Project	IEEE 802.16 Broadband Wireless Access Working Group		
Title	CR on SDD Chapter 15: Femtocell Cluster in IEEE 802.16m		
Date Submitted	2009-04-23		
Source(s)	Jun Zhou, Linghang Fan, Nader Zein,	E-mail:	jun.zhou@eu.nec.com
	NEC		
Re:	Category: SDD comments / Area: Chapter 15 (Femtocell) “Comments on SDD 15 Femtocell”		
Abstract	This contribution provides text addition to SDD to facilitate femtocell cluster in IEEE 802.16m		
Purpose	For discussion and approval by IEEE 802.16m TG		
Notice	<i>This document does not represent the agreed views of the IEEE 802.16 Working Group or any of its subgroups. It represents only the views of the participants listed in the “Source(s)” field above. It is offered as a basis for discussion. It is not binding on the contributor(s), who reserve(s) the right to add, amend or withdraw material contained herein.</i>		
Release	The contributor grants a free, irrevocable license to the IEEE to incorporate material contained in this contribution, and any modifications thereof, in the creation of an IEEE Standards publication; to copyright in the IEEE’s name any IEEE Standards publication even though it may include portions of this contribution; and at th

Figure X Illustration of the architecture of the femto cluster with femto cluster controller

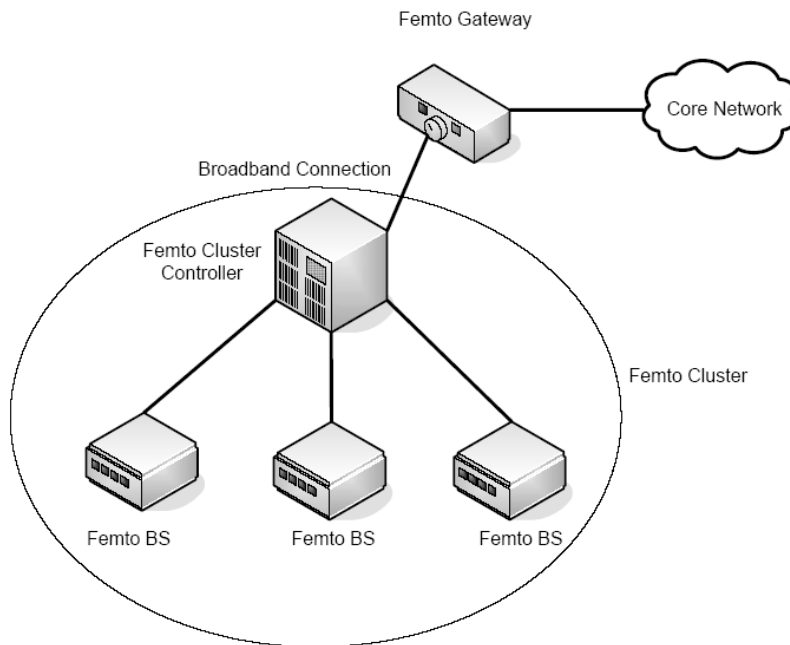
Modify the following text into the "Support for Femtocell" clause (IEEE 802.16m-08/003r8):

Femtocell cluster should be supported to cover a large area. The femtocell cluster controller should have the functionalities on RRM, security and traffic control, interference mitigation, and handover, etc.
